DATE: February 17, 2026
TO: ALL CONTRACTORS
FROM: DUSTINE TILL
PROJECT: ROSCOE ROAD WATER TREATMENT PLANT
ORANGE BEACH WATER AUTHORITY
GMC PROJECT NO. CMOB230049
RE: ADDENDUM #3

ADDENDUM NUMBER 3

ROSCOE ROAD WATER TREATMENT PLANT

GMC PROJECT NO. CMOB230049

FINISH LEGEND & SCHEDULE
A-781

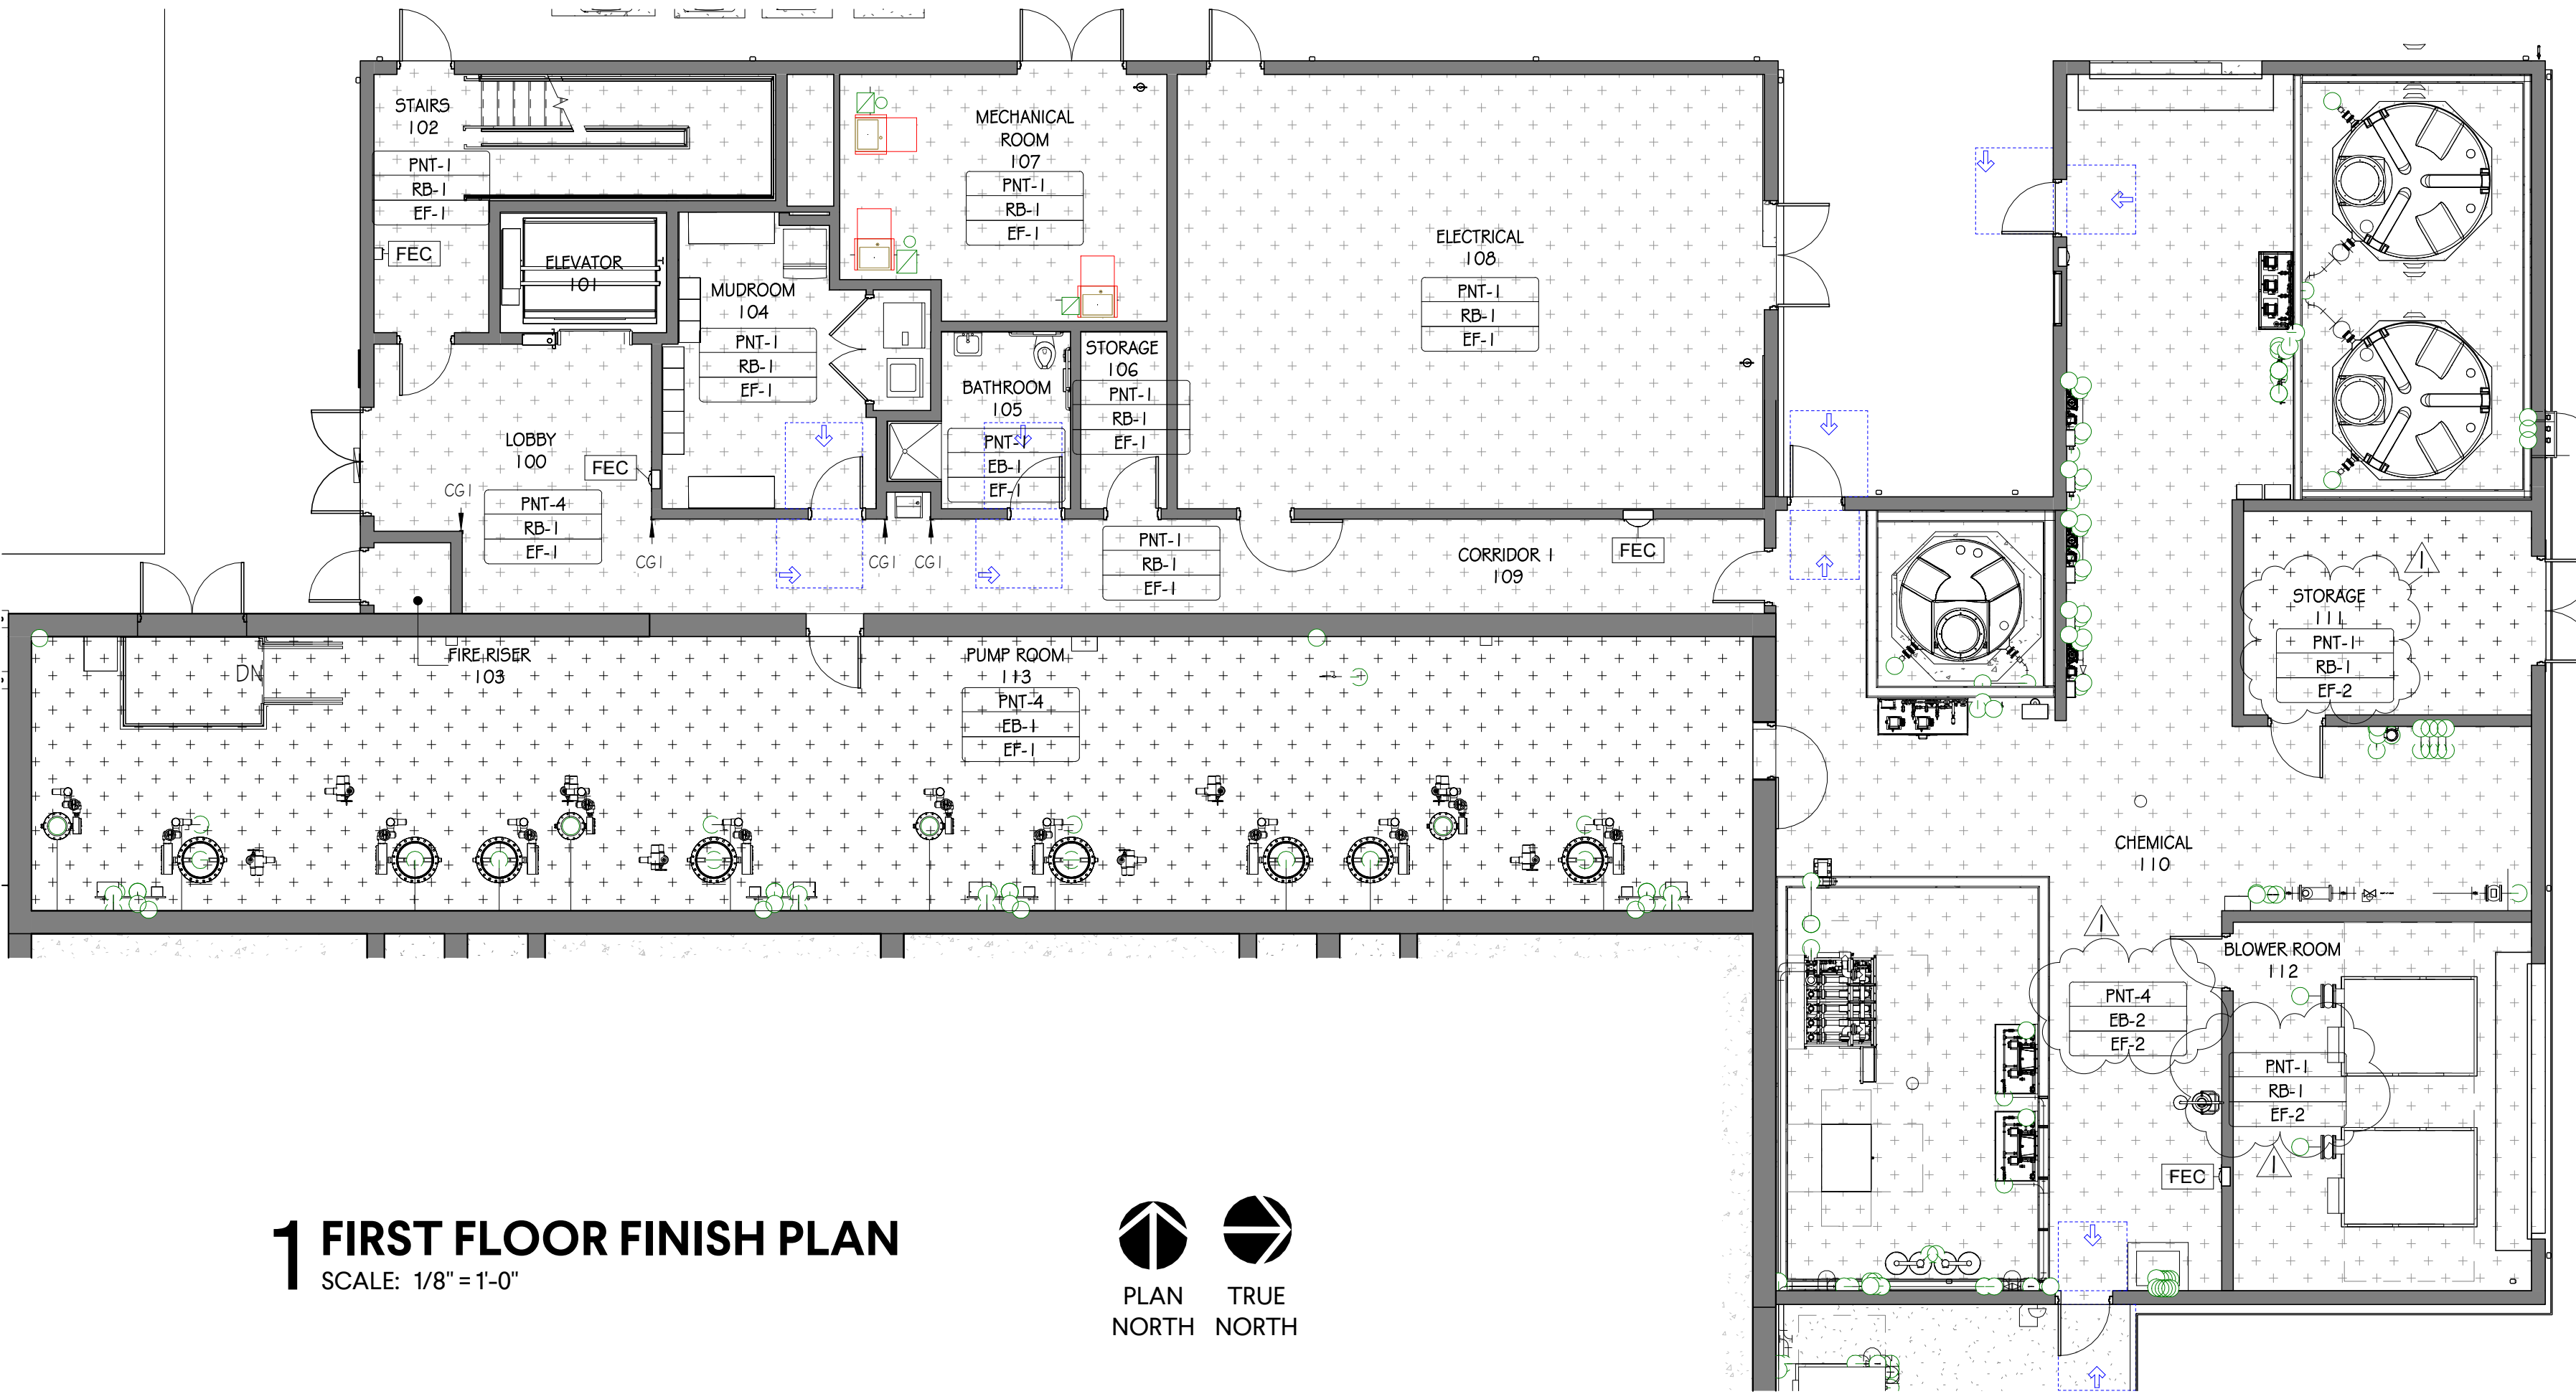
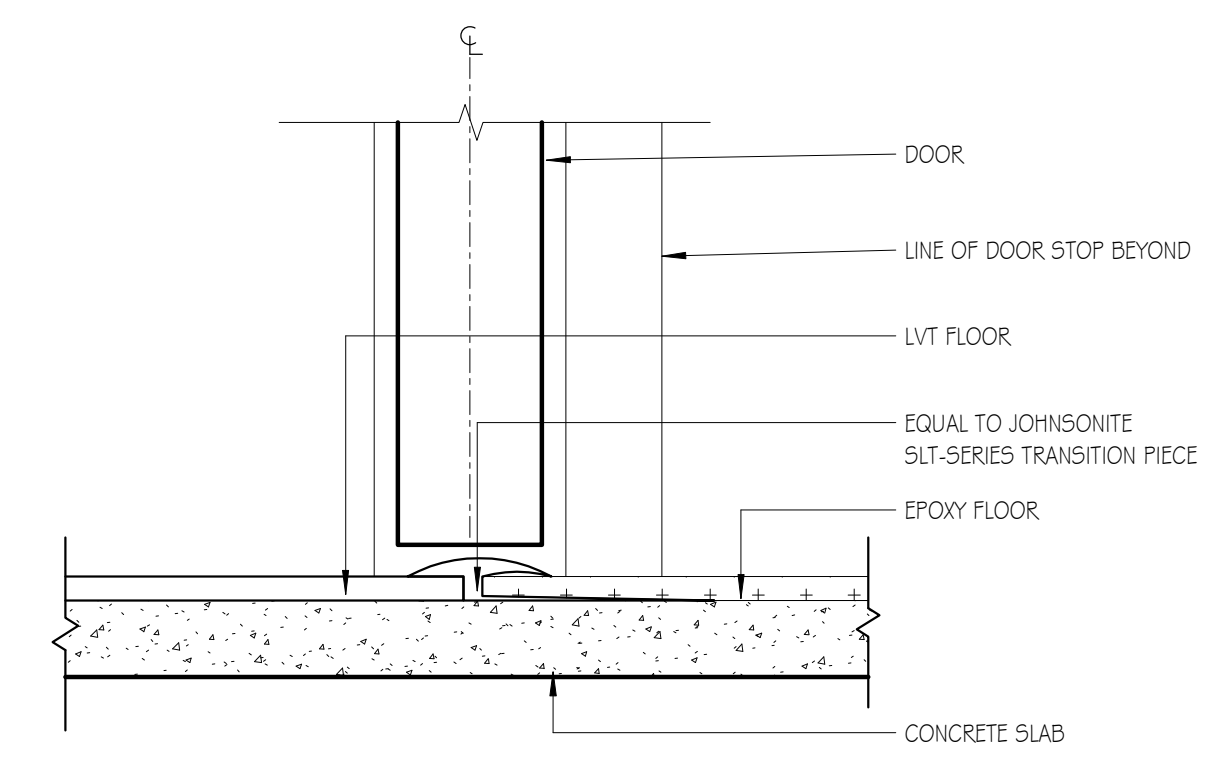
Answer: These are intended to be fabricated aluminum assemblies.
- 5.34 **Question: The Room Finish Schedule on Drawing A-781 lists “EF-1” and “EB-1” for the Epoxy Flooring and Epoxy Base in a majority of the Rooms. Both “EF-1” and “EB-1” are specified as Stonhard products on the Finish Legend. There is also a Specification Section 09 96 00-Slurry Epoxy Flooring based on Tnemec products. Please clarify where each of the products is to be applied.**

Answer: EF-1 and EB-1 has been revised from a Stonhard Stonshield product to a Tnemec Stratshield epoxy flooring or approved equal. See cloud on sheet A-781- FINISH LEGEND, & NOTES and sheet A-782-Finish Plan. EF-2 and EB-2 has been added and will be installed in the Chemical Storage Building. EF-2 and EB-2 will be Tnemec Chemical Resistance Coating for Secondary Containment or approved equal.

K CONCRETE SIDEWALK

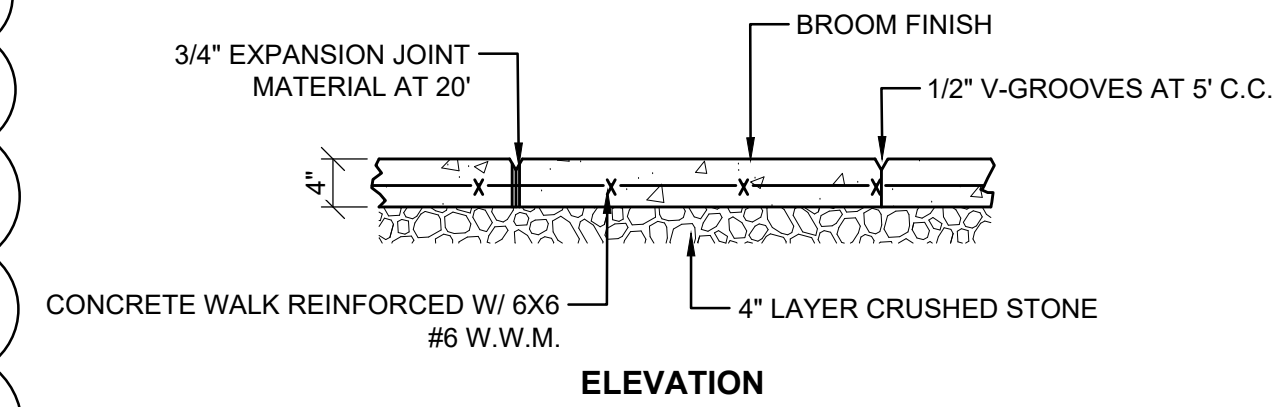
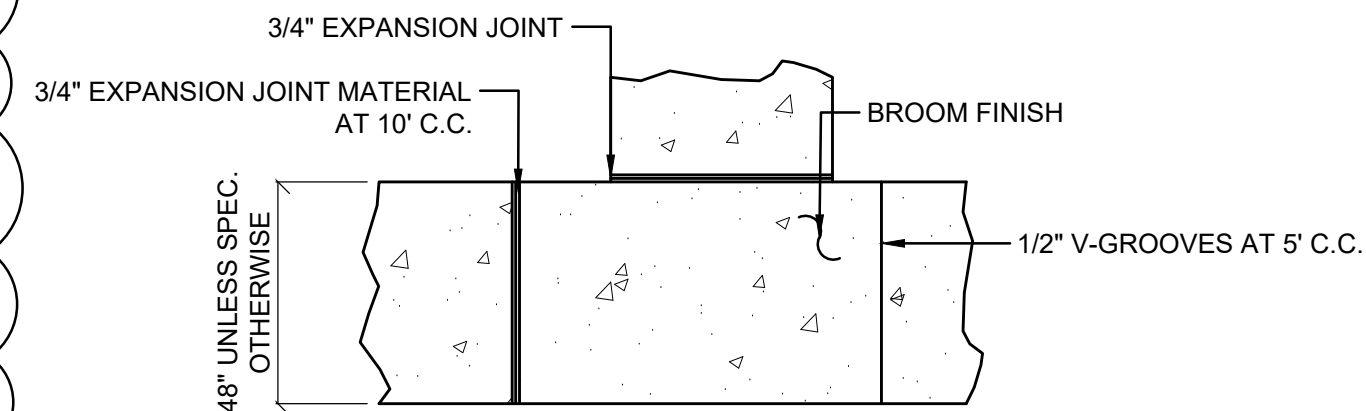
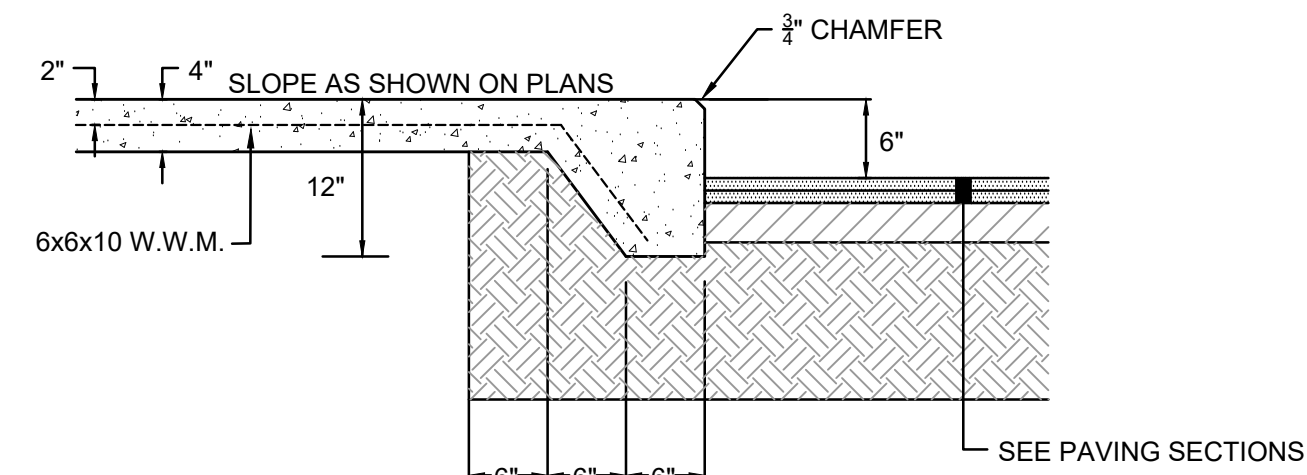
Answer: Yes, only the gate to the plant has an electric operator.
- 5.14 **Question: Referencing plan sheet C-902. There are two details for concrete sidewalk. Det J and Detail K. One shows the sidewalk to be 8" thick and the other 4". Which is correct?**

Answer: Detail K shall be used for concrete sidewalks.
